ADDENDUM NO. 1

DATE: January 21, 2026

FROM: Matt Filla, PE, on behalf of the Town of Palisade

RE: Sewer Transfer Project

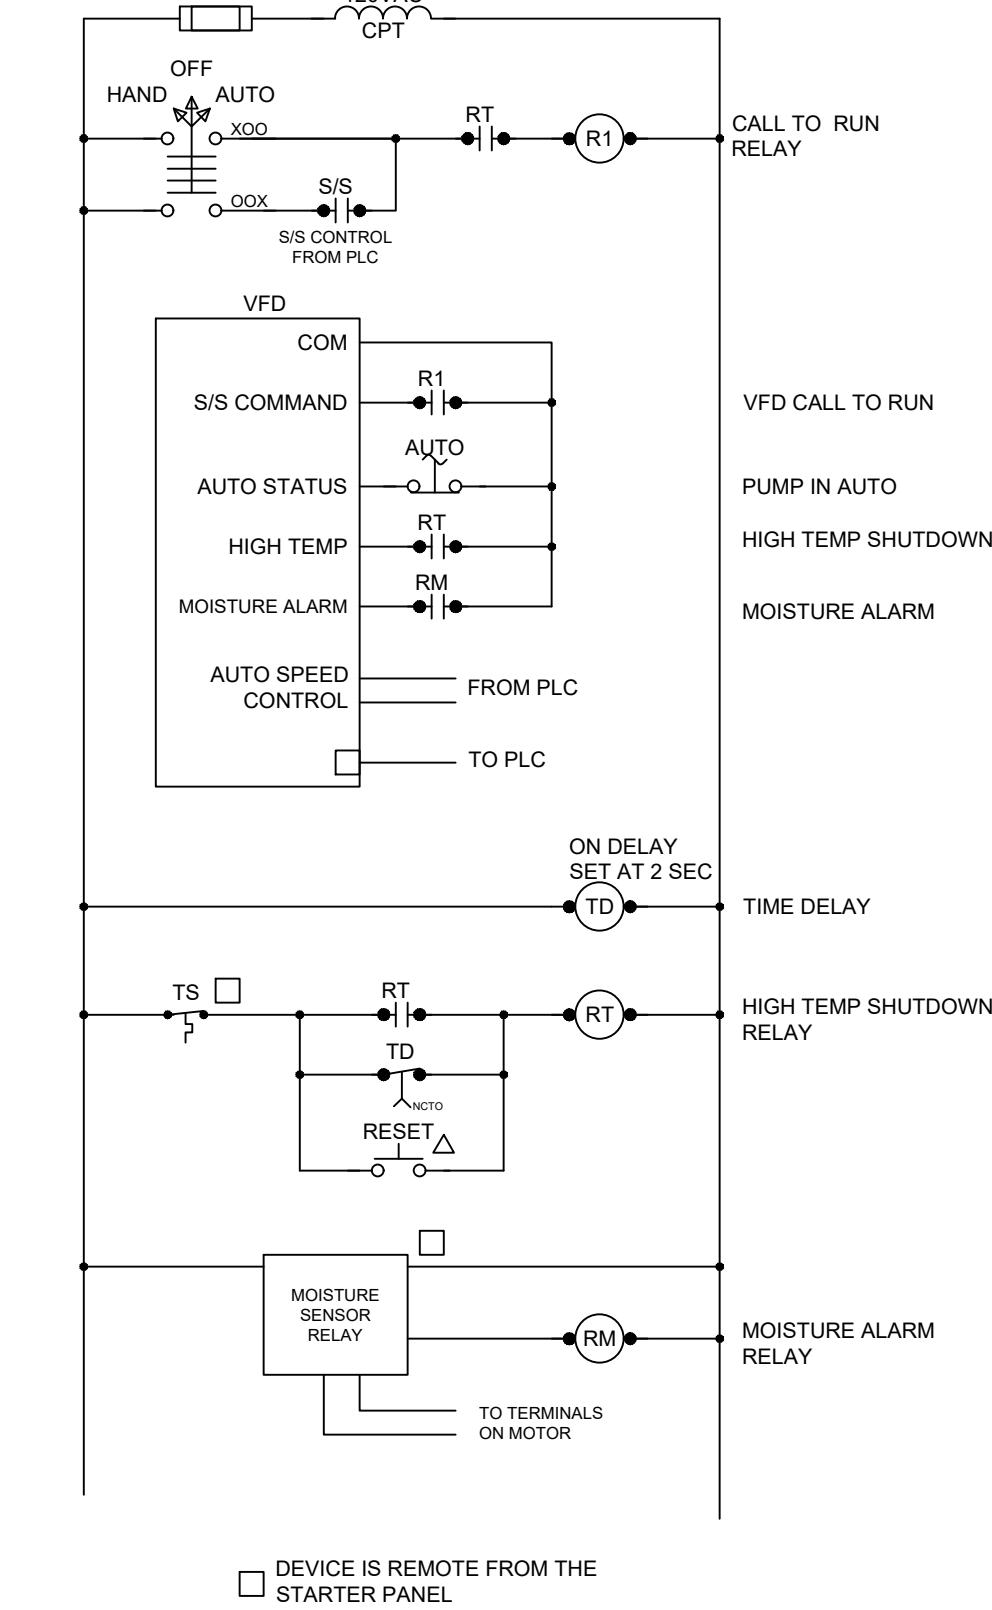
16. Question: Can you please tell me if the controls engineer has set up the Scada PLC Panel, Odor Control Panel and the sensors with a manufacturer and distributor? These are very specialized panels and will need to be specified and built specifically for the Palisade project.

Response: Panel specifications have not been provided to a manufacturer or distributor. The Contractor shall provide the SCADA PLC panel as designed in the drawings and specifications. The pump control panel is to be provided by the pump manufacturer (Flygt) and the odor control panels are to be provided by their manufacturers (Heartland and Vapex). The Electrical Controls sheets (EC-1,2,3) and the P&ID sheets (I-1,2) have been updated to reflect this. Specification 40 95 00 has also been modified to show the updated I/O list.

NOTES:
 1. J-BOX TO BE LOCATED NEAR WET WELL.
 2. J-BOX TO BE LOCATED NEAR PUMP MOUNTING BASE.
 3. FLYGT IS TO PROVIDE PUMP CONTROL PANEL.
 4. SCADA CONTROL PANEL IS PROVIDED BY CONTRACTOR.

PUMP #1 & #2
 ALL CONTROL SHALL BE HARDWIRED. SIGNALS BACK TO THE PLC SHALL BE OVER ETHERNET.
 *FLYGT TO PROVIDE VFD CONTROL PANEL
